# Access Compliance Report

## Public Rights-of-Way

### (Curb Ramps)

| Intersection ID: 10035937 | Main Street: RICHLAND_DR | Cross Street: N/A       | Location: E            |

| ADA ID: D8CB2172CAFF      | Ramp Type: PerpDiag      | Initial Pass/Fail: Fail | Overall Compliance: No |

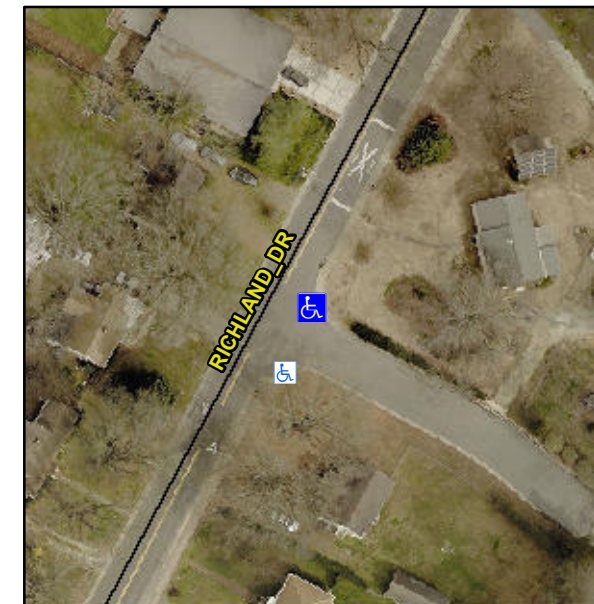
**Not Found, R304.2.2, R304.5.3**

| Compliance | Description           | Data  | Compliance | Description                 | Data  |
|------------|-----------------------|-------|------------|-----------------------------|-------|
| N/A        | Ramp Length (in)      | 51.0  | No         | Ramp Slope (%)              | 12.2  |
| Yes        | Ramp Width (in)       | 48.0  | No         | Ramp XSlope (%)             | 3.9   |

**Remove & Replace Curb Ramp With Two New Directional Ramps or Equivalent.**
